## PLAN COMMISSION

December 14, 2020 @ 5:30 p.m.  
Zoom Meeting:

**CBLOOMINGTON PLAN COMMISSION**  
**STAFF REPORT – Second Hearing**  
**Location: 300 W. Hillside Drive**

**CASE #: PUD-17-20**  
**DATE: December 14, 2020**

**PROPOSED BUILDING ELEVATIONS**

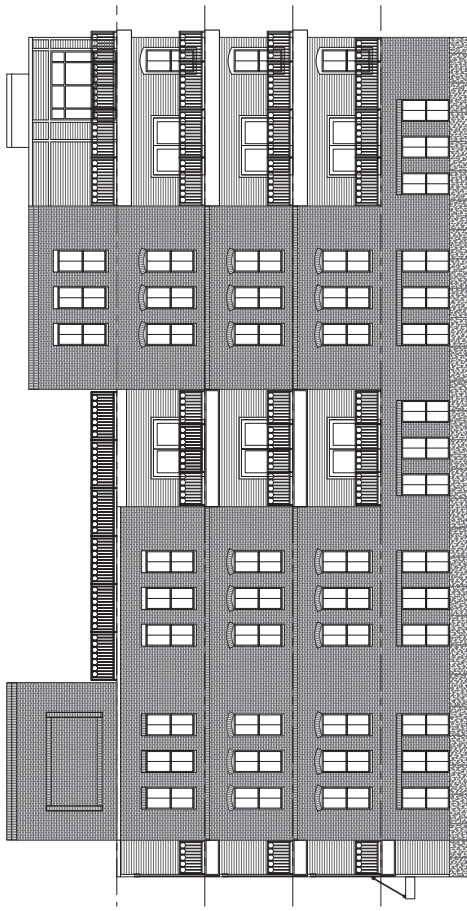
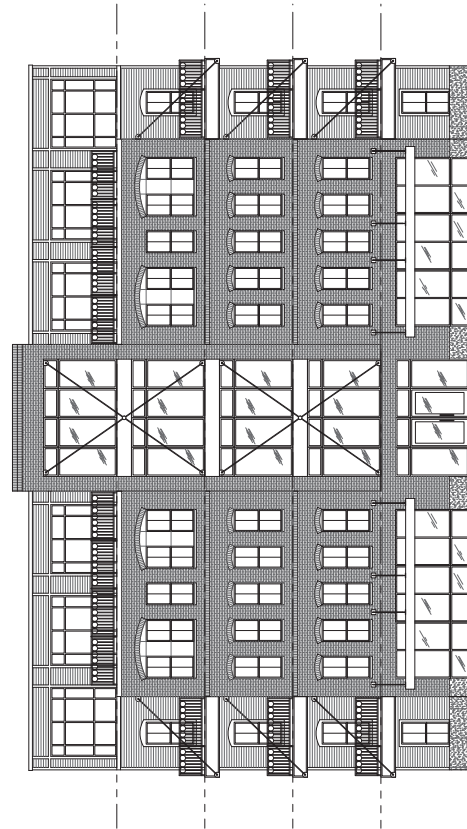
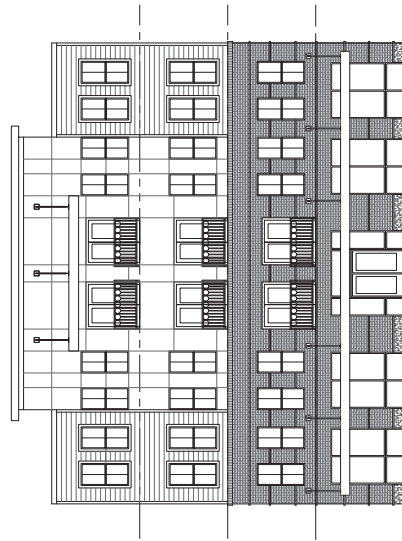
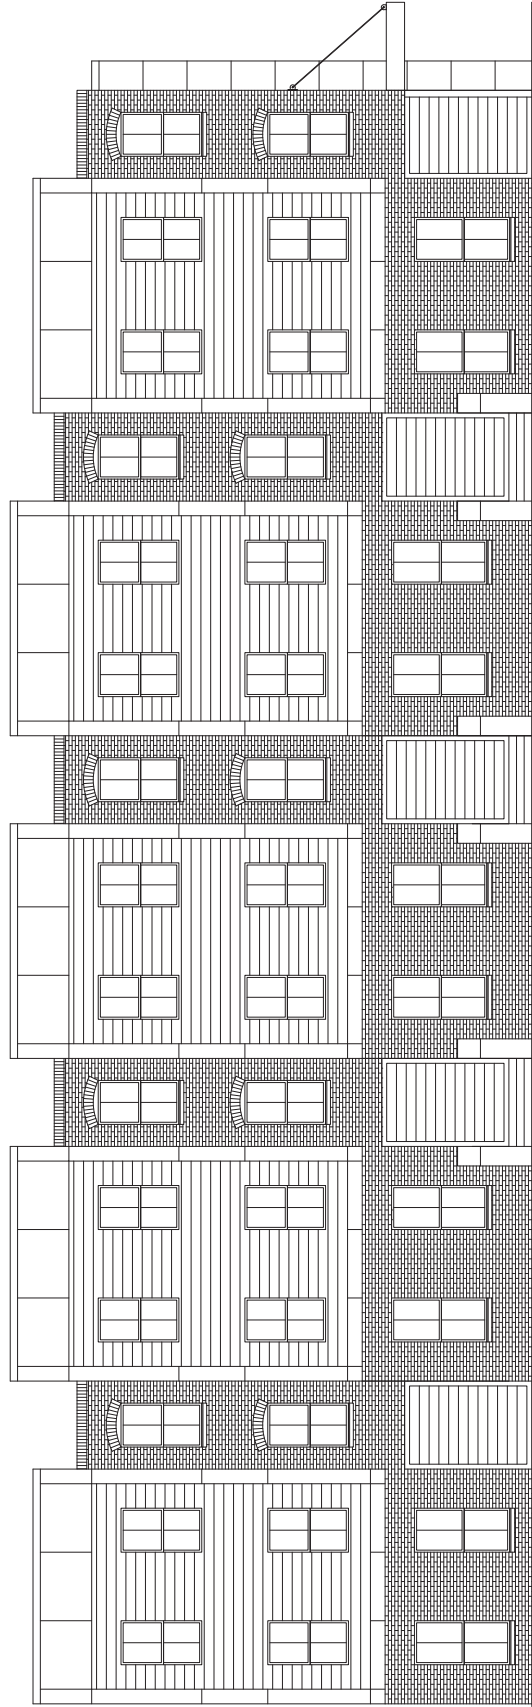
**Architecture/Materials:** Renderings of all of the proposed buildings have been submitted and are included in the packet. The Department believes that additional improvements can be made for the portions of the townhome buildings facing the Switchyard Park. Additional renderings were submitted after the revision deadline that show balconies along the trail and better entrance design, however the Department wants to insure a high level of design and pedestrian interaction along the Park facades. Another concern of the Department is the bottom two floors of the building proposed south of Hillside Drive. The bottom two floors of that building consist entirely of parking

with no active ground floor use, especially along the Park façade. This should be modified to include a different use along the trail façade. A brief description of the exterior finishing materials has been listed, however this list should be amended to specifically state what the approved exterior finishing materials are and to prohibit EIFS as a primary material.
